TRANS/WP.29/935

World Forum for Harmonization of Vehicle Regulations (WP.29)

DRAFT SUPPLEMENT 23 TO THE 03 SERIES  
OF AMENDMENTS) TO REGULATION No. 37

(Filament lamps)

**Sheet R5W/1**

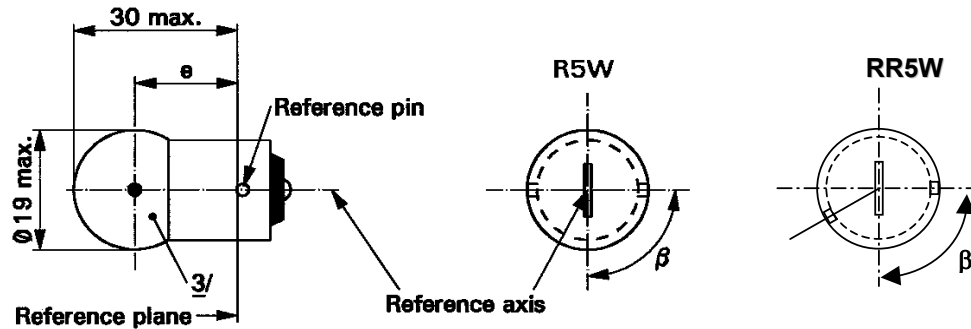
Sheet R5W/1, replace by the new sheet R5W/1 (Category R5W and RR5W).

Dimensions in mm	Filament lamps of normal production			Standard filament lamp	
	min.	nom.	max.	4/	
e	17.5	19.0	20.5	19.0 ± 0.3	
Lateral deviation 2/			1.5	0.3 max.	
β	60°	90°	120°	90° ± 5°	
Cap: R5W: BA15s RR5W: BAW15s	in accordance with IEC Publication 60061			(sheet 7004-11A-9) 1/ (sheet 7004-11E-1)	
<b>ELECTRICAL AND PHOTOMETRIC CHARACTERISTICS</b>					
Rated values	Volts	6 5/	12	24	12
	Watts	5			5
Test voltage	Volts	6.75	13.5	28.0	13.5
Objective values	Watts	5.5 max.		7.7 max.	5.5 max.
	Luminous flux	R5W	50 ± 20 %		
		RR5W	5/	12 ± 25 %	
Reference luminous flux at approximately 13.5 V:		White: 50 lm Red: 12 lm

**Sheet R10W/1**

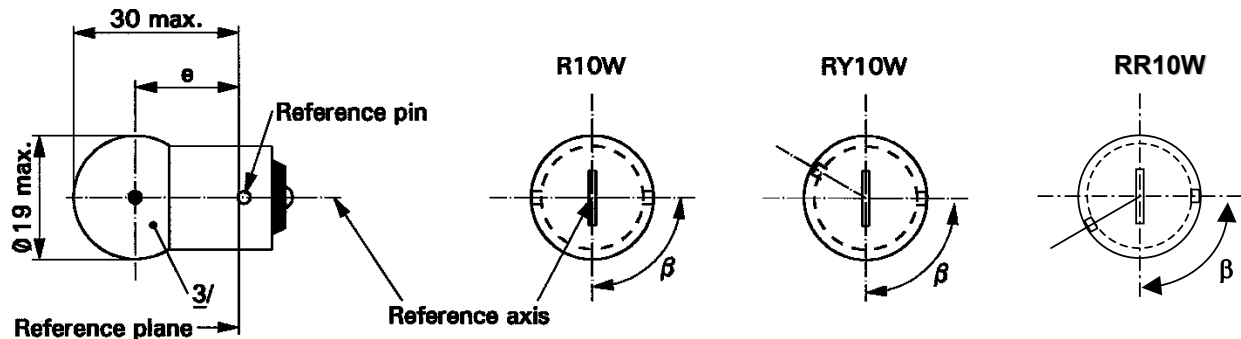
Sheet R10W/1, replace by the new sheet R10W/1 (Category R10W, RY10W and RR10W).

Dimensions in mm		Filament lamps of normal production			Standard filament lamp	
		min.	nom.	max.	<u>4/</u>	
E		17.5	19.0	20.5	19.0 ± 0.3	
Lateral deviation <u>2/</u>				1.5	0.3 max.	
β		60°	90°	120°	90° ± 5°	
R10W: BA15s Cap: RY10W: BAU15s in accordance with IEC Publication 60061 RR10W: BAW15s					(sheet 7004-11A-9) <u>1/</u> (sheet 7004-19-1) (sheet 7004-11E-1)	
<b>ELECTRICAL AND PHOTOMETRIC CHARACTERISTICS</b>						
Rated values		Volts	6 <u>5/</u>	12	24	12
		Watts	10			10
Test voltage		Volts	6.75	13.5	28	13.5
Objective values	Watts	R10W RY10W	11 max.		14 max.	11 max.
		RR10W	<u>5/</u>	11 max.		11 max.
	Luminous flux	R10W	125 ± 20 %			
		RY10W	75 ± 20 %			
		RR10W	<u>5/</u>	30 ± 25 %		
Reference luminous flux at approximately 13.5 V:		White: 125 lm Amber: 75 lm Red: 30 lm

**Sheet W5W/1**

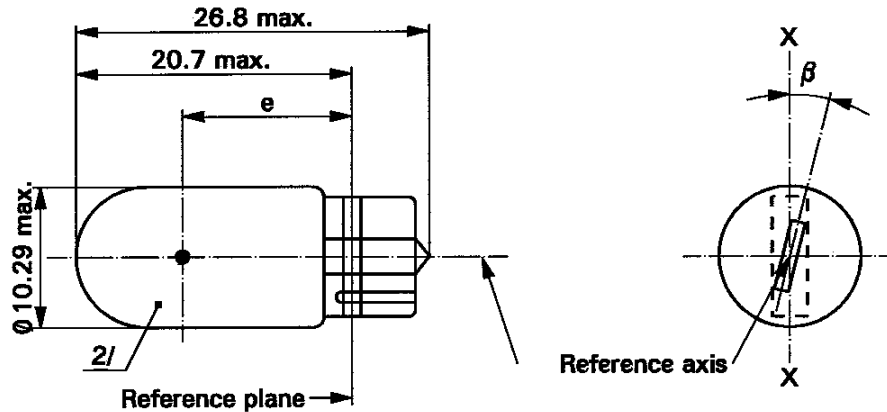
Sheet W5W/1, replace by the new sheet W5W/1 (Category W5W, WY5W and WR5W).

Dimensions in mm		Filament lamps of normal production			Standard filament lamp
		min.	nom.	max.	<u>3/</u>
E		11.2	12.7	14.2	12.7 ± 0.3
Lateral deviation	<u>1/</u>			1.5	0.5 max.
β		- 15°	0°	+ 15°	0° ± 5°
Cap W2.1x9.5d in accordance with IEC Publication 60061 (sheet 7004-91-3)					
<b>ELECTRICAL AND PHOTOMETRIC CHARACTERISTICS</b>					
Rated values	Volts	6 <u>4/</u>	12	24	12
	Watts	5			5
Test voltage	Volts	6.75	13.5	28.0	13.5
Objective values	Watts	5.5 max.		7.7 max.	5.5 max.
	Luminous flux	W5W	50 ± 20 %		
		WY5W	30 ± 20 %		
		WR5W	<u>4/</u>	12 ± 25 %	
Reference luminous flux At approximately 13.5 V:		White: 50 lm Amber: 30 lm Red: 12 lm

**Sheet P19W/1**

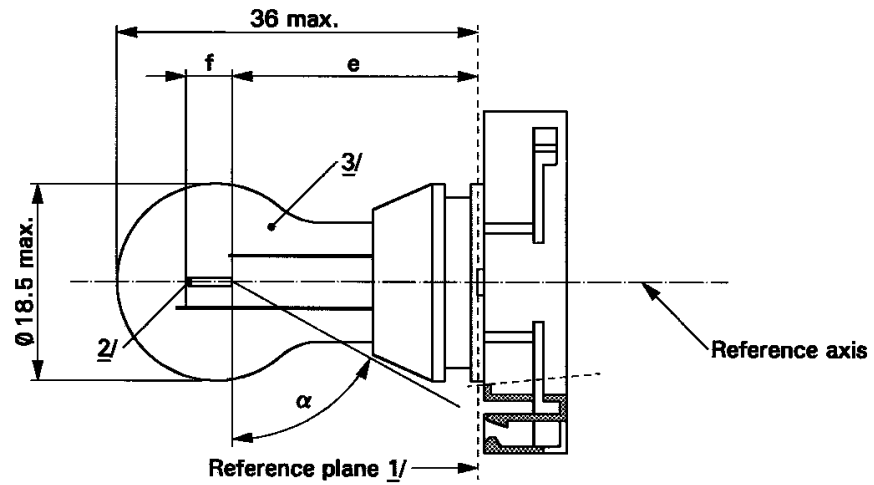
Sheets P19W/1 to P19W/3, replace by the new sheets P19W/1 to P19W/3 (Category P19W, PY19W, PR19W, PS19W, PSY19W, PSR19W).

- 1/ The reference plane is defined by the meeting points of the cap-holder fit.
- 2/ No actual filament diameter restrictions apply but the objective is  $d_{max} = 1.1$  mm.
- 3/ The light emitted from normal production lamps shall be white for categories P19W and PS19W; amber for categories PY19W and PSY19W; red for categories PR19W and PSR19W. (See also note 8/)

**CATEGORIES P24W, PY24W, PR24W, PS24W, PSY24W AND PSR24W****Sheet P24W/2**

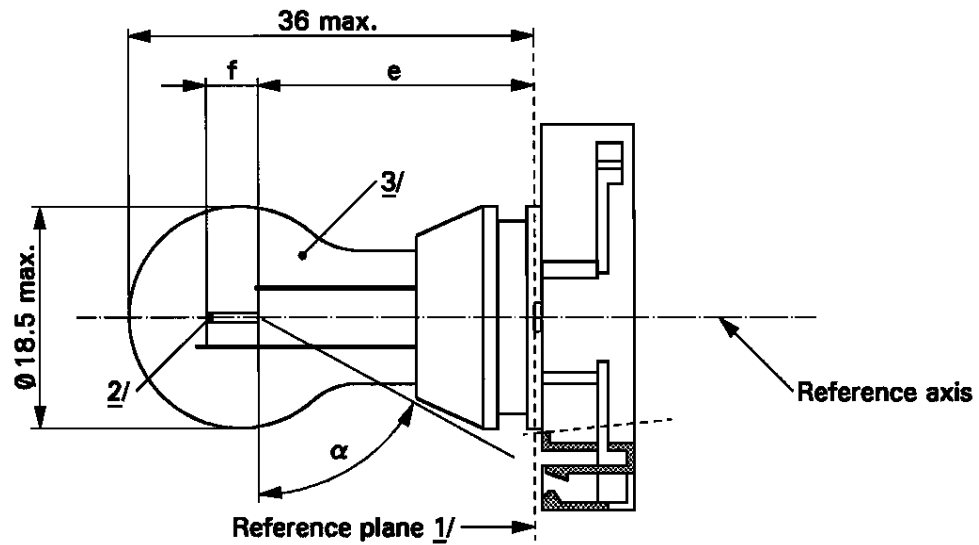
Sheets P24W/1 to P24W/3, replace by the new sheets P24W/1 to P24W/3 (Category P24W, PY24W, PR24W, PS24W, PSY24W, PSR24W).

- 1/ The reference plane is defined by the meeting points of the cap-holder fit.
- 2/ No actual filament diameter restrictions apply but the objective is  $d_{max} = 1.1$  mm.
- 3/ The light emitted from normal production lamps shall be white for categories P24W and PS24W; amber for categories PY24W and PSY24W; red for the categories PR24W and PSR24W. (See also note 8/)

Sheet PR21W/1

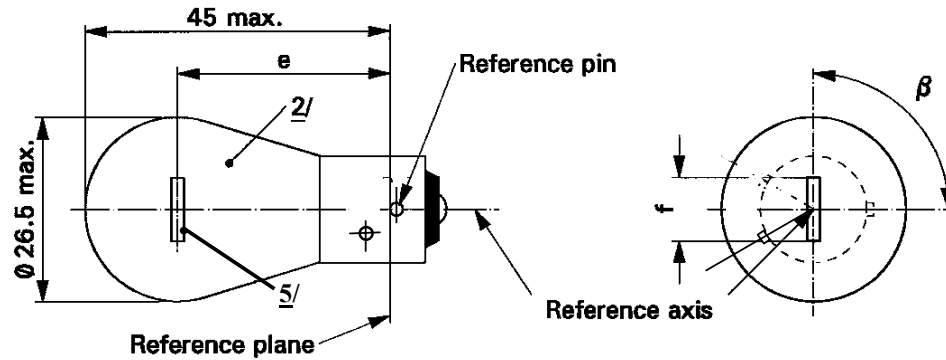
Add at the end new sheets PR21W/1, PR21/4W/1, PR21/5W/1 and PR27/7W/1.

Dimensions in mm		Filament lamps of normal production			Standard filament lamp
		min.	nom.	max.	<u>4/</u>
E	12 V		31.8 <u>3/</u>		31.8 ± 0.3
	24 V	30.8	31.8	32.8	
F	12 V	5.5	6.0	7.0	6.0 ± 0.5
Lateral <u>1/</u> deviation	12 V			<u>3/</u>	0.3 max
	24 V			1.5	
$\beta$		75°	90°	105°	90° ± 5°
Cap BAW15s in accordance with IEC Publication 60061 (sheet 7004-11E-1)					
ELECTRICAL AND PHOTOMETRIC CHARACTERISTICS					
Rated values	Volts	12	24	12	
	Watts	21			21
Test voltage	Volts	13.5	28.0		
Objective values	Watts	26.5 max.	29.7 max.	26.5 max.	
	Luminous flux	110 ± 20 %			
Reference luminous flux at approximately 13.5 V:		White:	460 lm		
		Red:	110 lm

## Sheet HS5/3

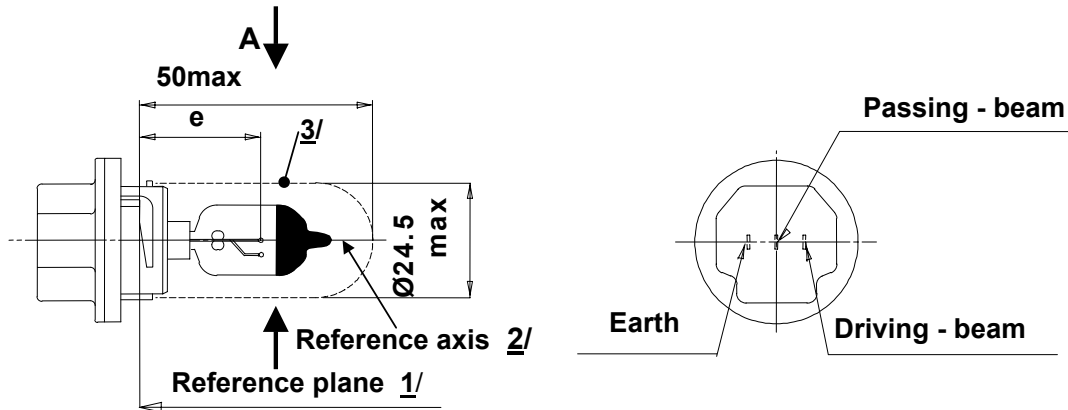
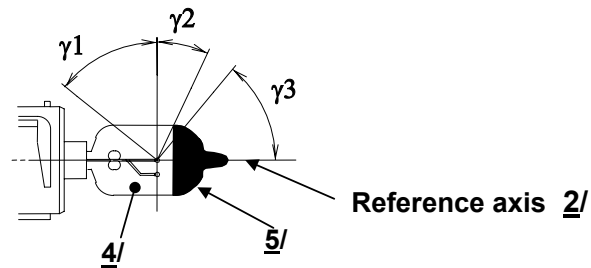
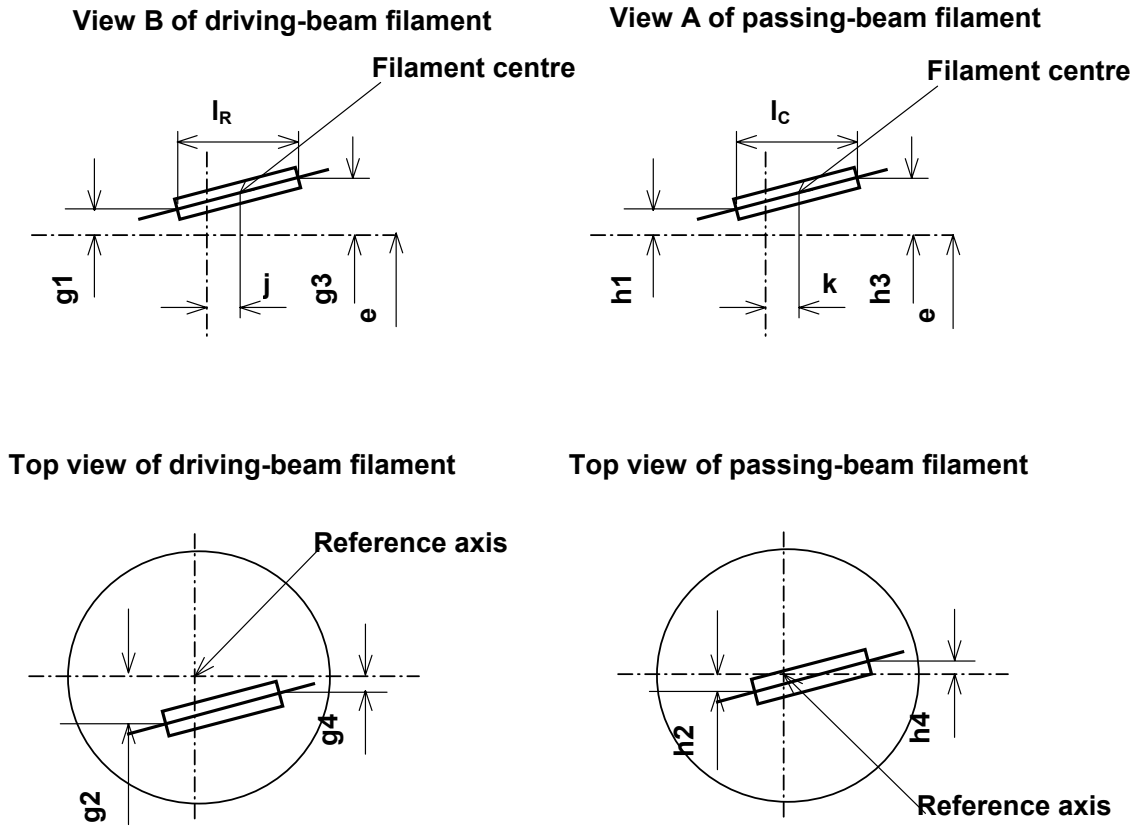
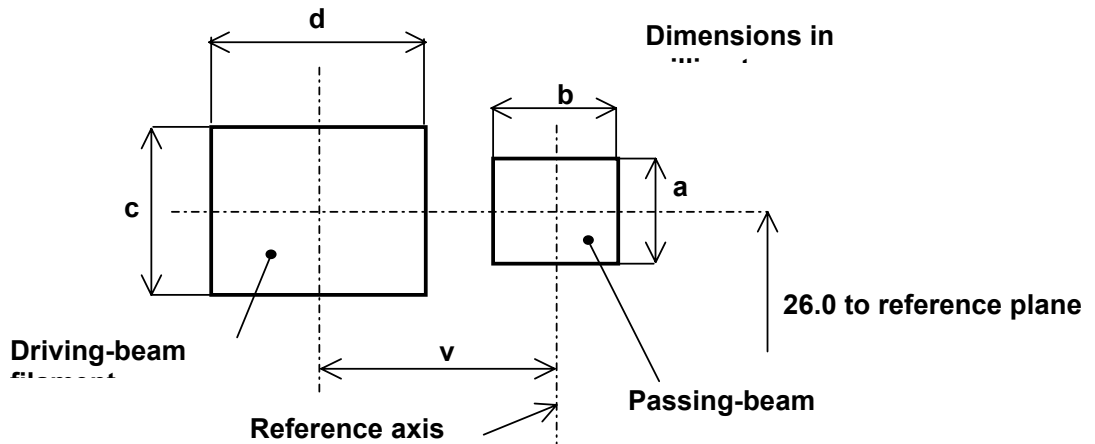
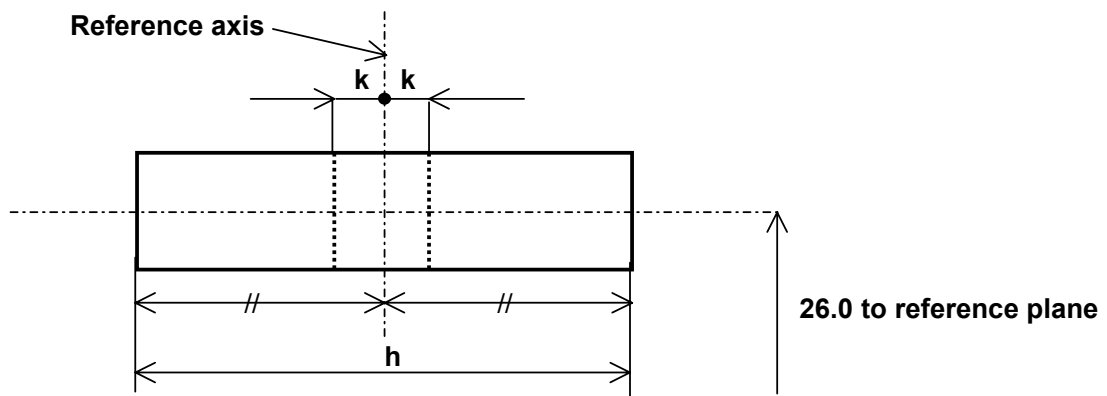
Add at the end new sheets HS5/1 to HS5/4.

Dimensions in mm		Filament lamps of normal production		Standard filament lamp		
		12V		12V		
e	26	6/		± 0.15		
l <sub>c</sub>	<u>7/</u> 4.6			± 0.3		
k	0			± 0.2		
h1, h3	0			± 0.15		
h2, h4	0			± 0.20		
l <sub>R</sub>	<u>7/</u> 4.6			± 0.3		
j	0			± 0.2		
g1, g3	0			± 0.30		
g2, g4	2.5			± 0.40		
γ <sub>l</sub>	50° min.	-		-		
γ <sub>l</sub>	23° min.	-		-		
γ <sub>l</sub>	50° min.	-		-		
Cap P23t in accordance with IEC Publication 60061 (sheet 7004-....-1)						
ELECTRICAL AND PHOTOMETRIC CHARACTERISTICS						
Rated values	Voltage	V	12		12	
	Wattage	W	35	30	35	30
Test voltage		V	13.2		13.2	
Objective Values	Wattage	W	40 max.	37 max.	40 max.	37 max.
	Luminous flux	lm	620	515		
		± %		15	15	
Reference luminous at approximately 12V				460 lm	380 lm
